## Brattleboro BRO 1442 (35)

### Temporary Bridge Revision 2 Explanation

### **Temporary Bridge Re-submittal**

SOUTHBOUND MOVEMENT

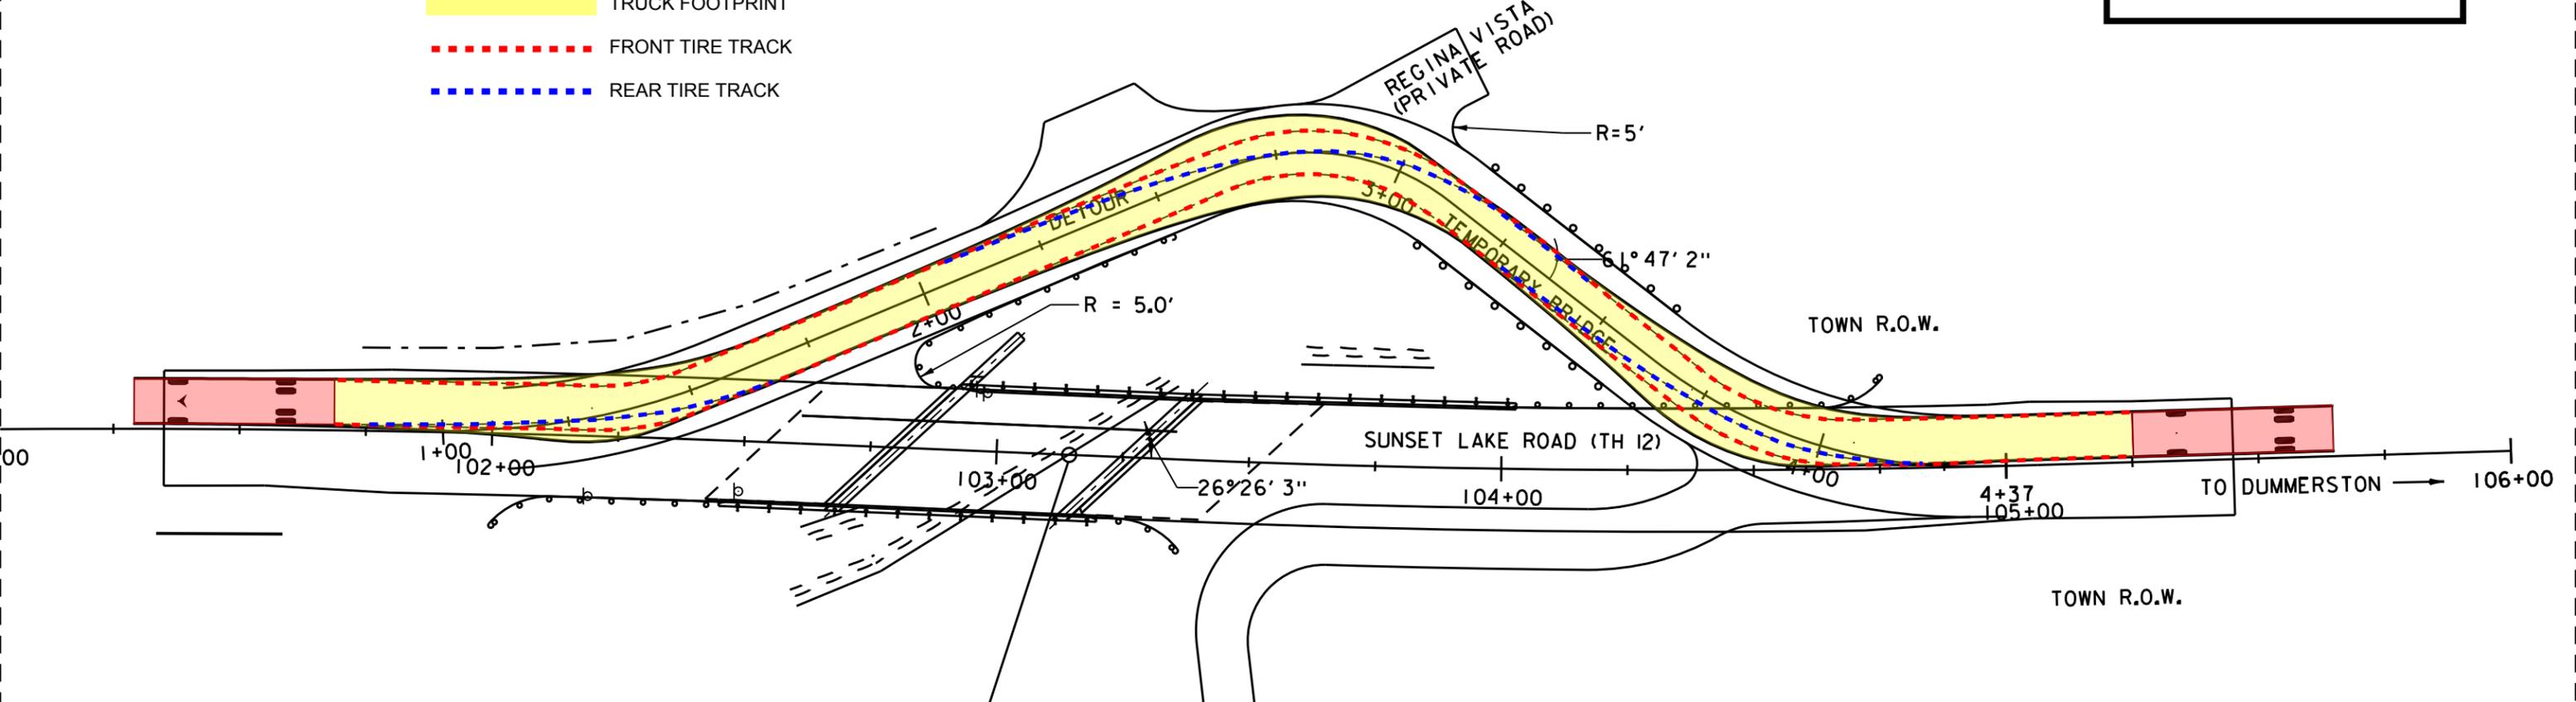
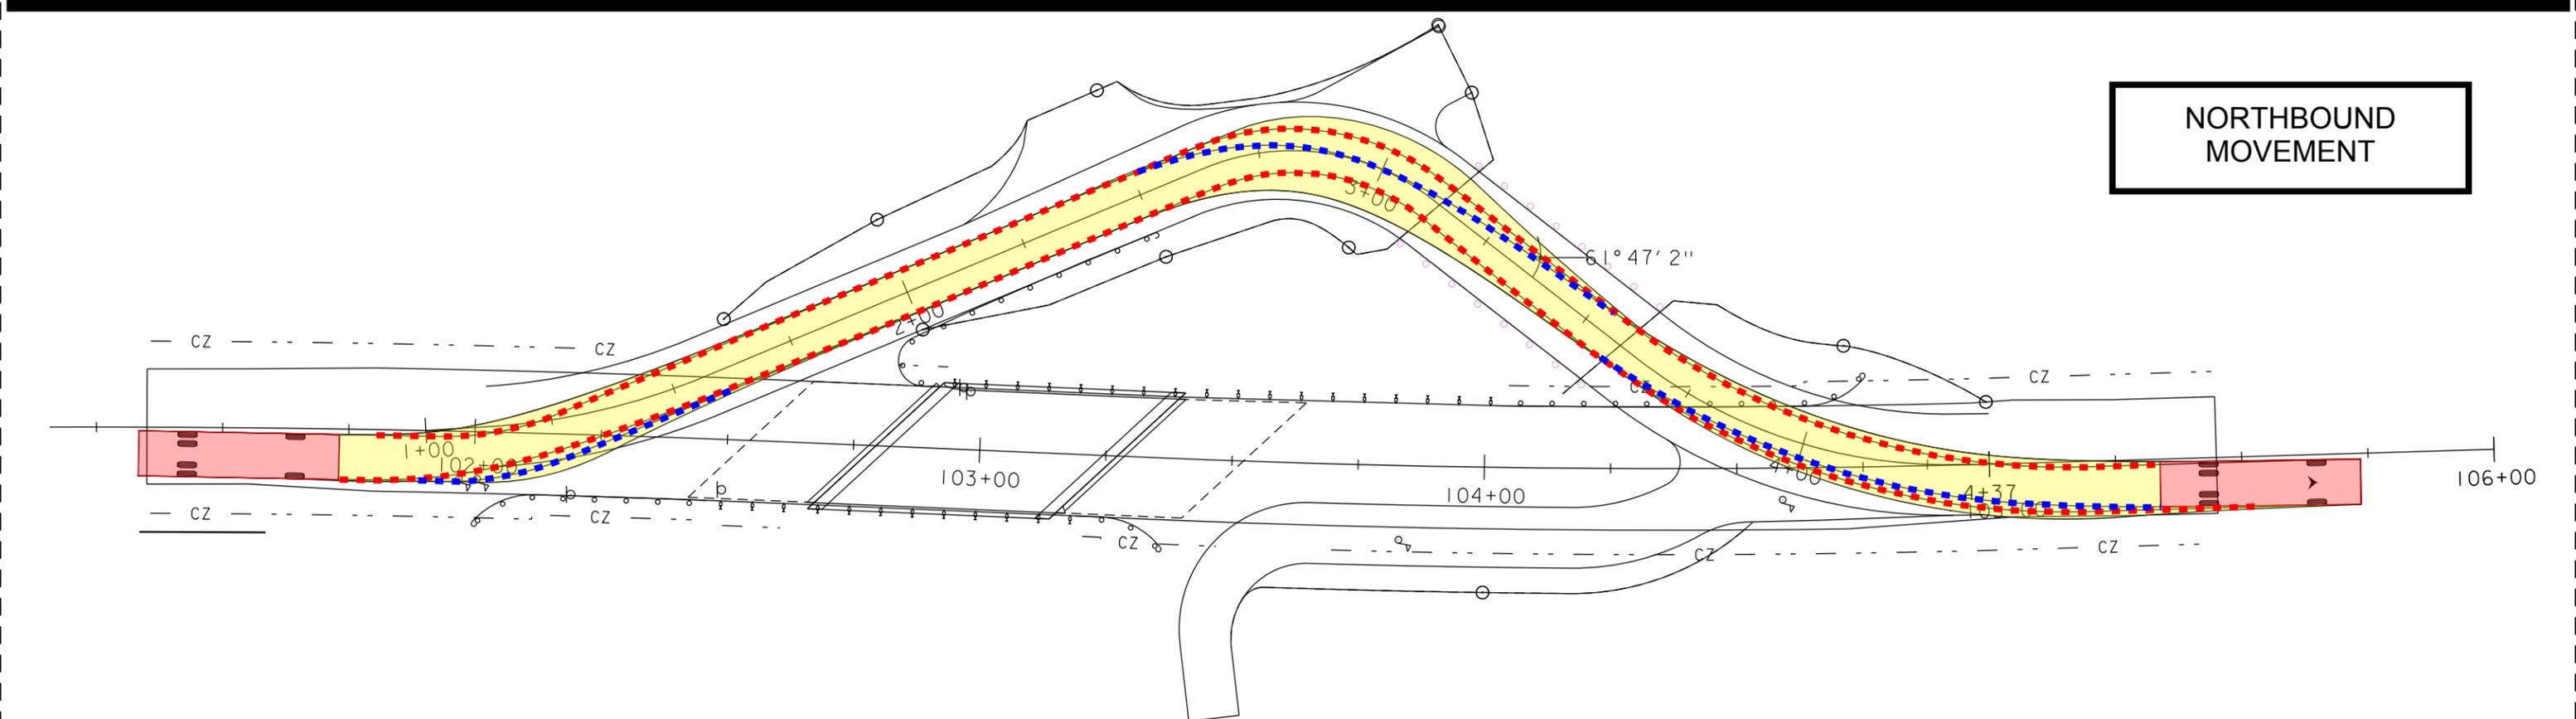
**From:** Burbank, Scott [<mailto:SBurbank@VHB.com>]  
**Sent:** Wednesday, March 05, 2014 5:36 PM  
**To:** Chenette, Michael  
**Cc:** [mike.chenette@stantec.com](mailto:mike.chenette@stantec.com); Sumner, Todd  
**Subject:** Brattleboro BRO 1442(35) - Ladder Truck Turning Movements

Based on the attached information provided by Michael Bucossi, Town of Brattleboro Fire Chief, we developed a model of the Brattleboro Ladder Truck in AutoTurn which we “drove” through the detour using the AutoTurn program. As noted in the attached PDF the Brattleboro Ladder Truck is capable of maneuvering through the detour.

The ladder truck turning movements have been reviewed and it looks like it should be capable of maneuvering through the detour, as designed.

REV.			JOB NAME: BRATTLEBORO
NO. DATE COMMENTS			JCB NO: BRC 1442(35)
1 5/5/14 WIDEN APPROACH			SHEET NAME: RAIL ATTACHMENT DETAIL
DATE: 1/31/14			
DRAWN BY: A.D.			
CHK'D BY: C.E.			
			SHEET: 6

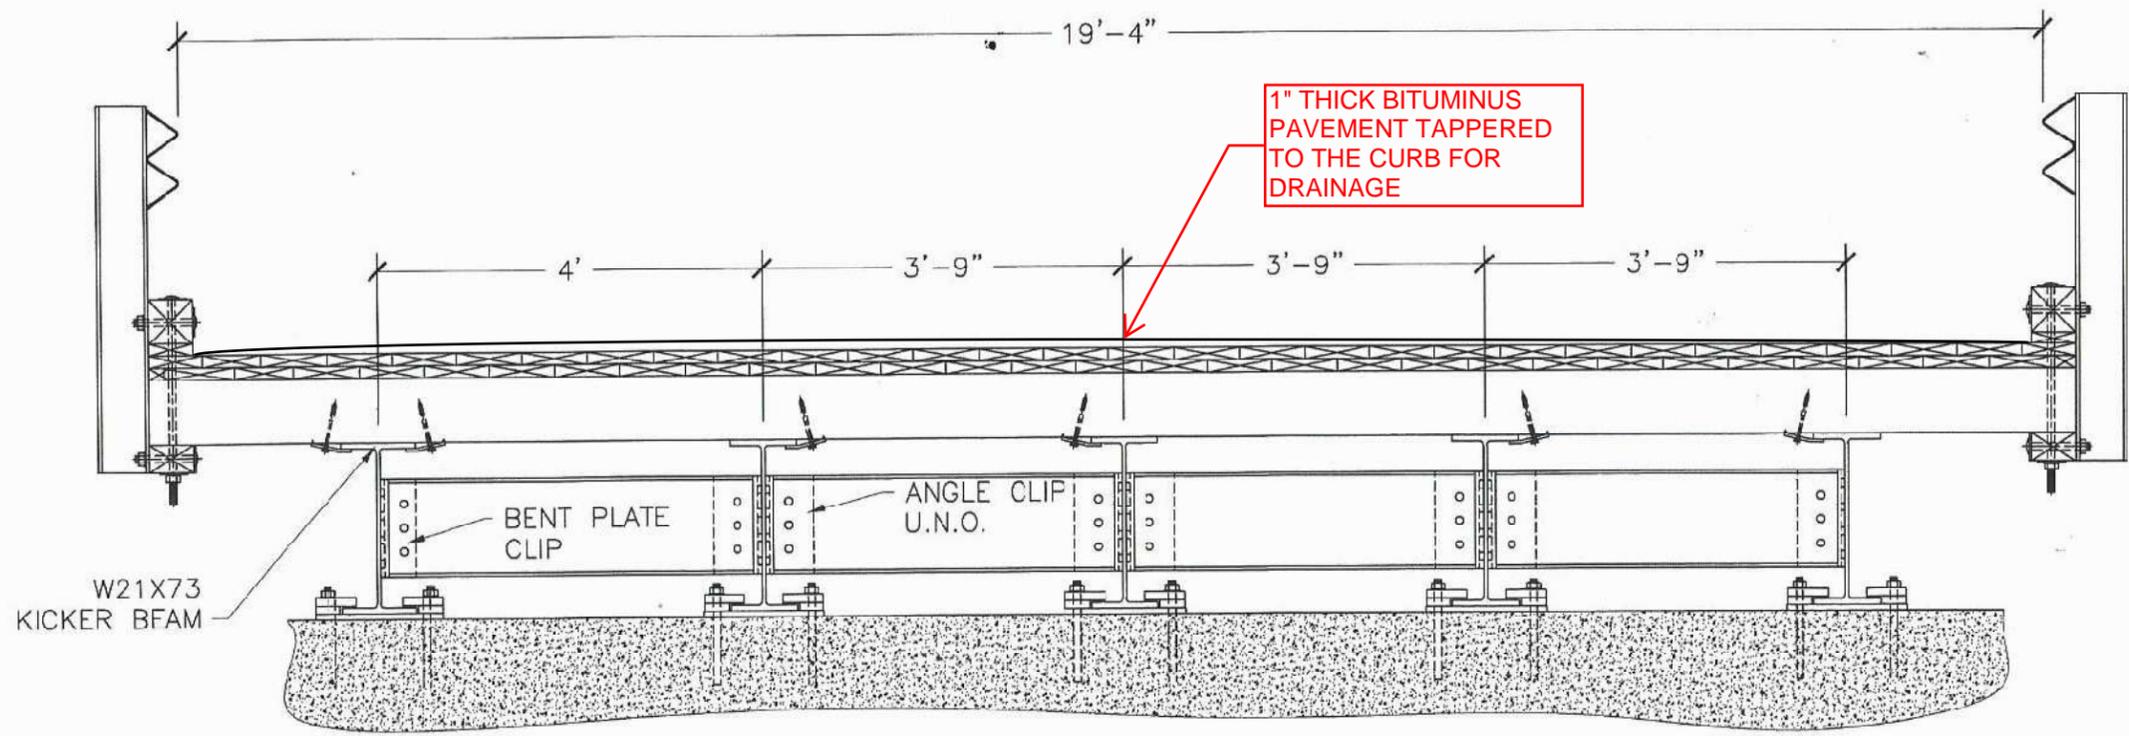
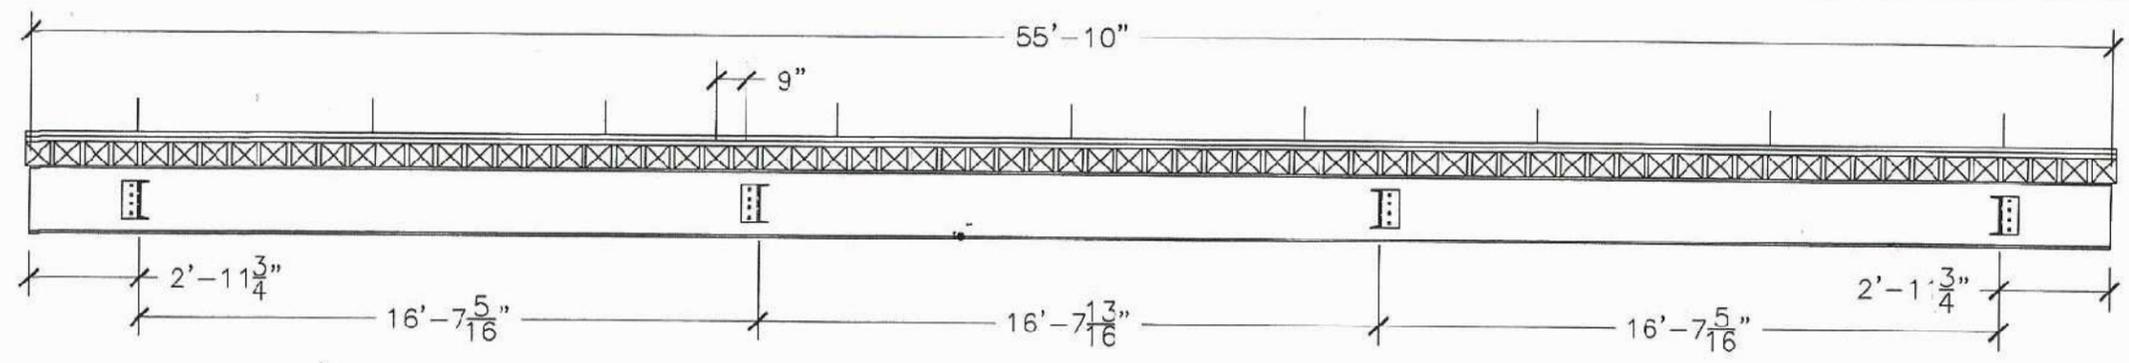
3. Additional information on how drainage will be provided for on the bridge.

Sheets 6 and 8 show how the bridge drains with an inch of pavement tapered to the curb where the 1 ½" spacer is staggered so water can run off the bridge deck.

**CRANE LAYOUT PLAN**

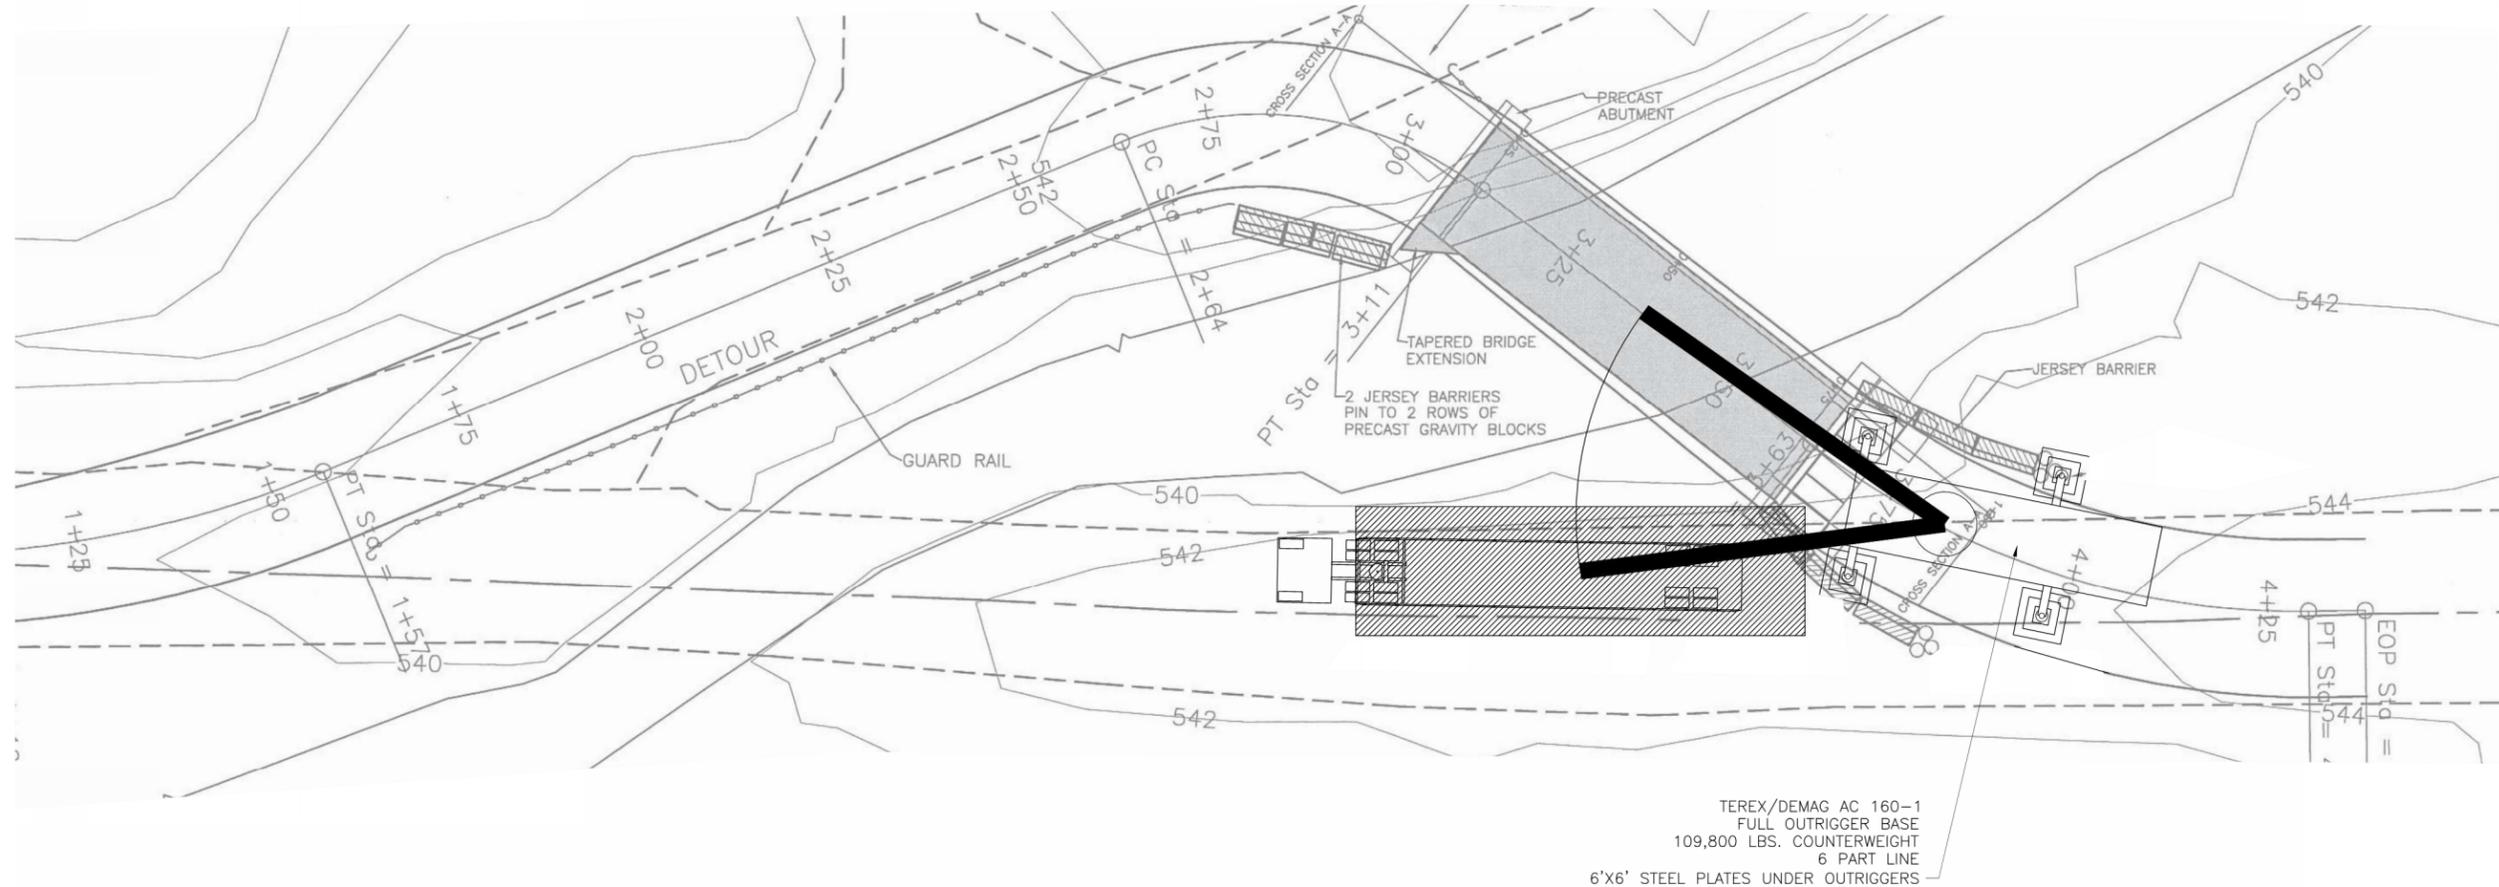
2. Additional information on the method of erection (not just the sequence) of the temporary bridge that satisfies Specification Section 528.04(b)(3).

An erection plan has been included showing the crane placement, lifting capacities, radius, and rigging capacities.
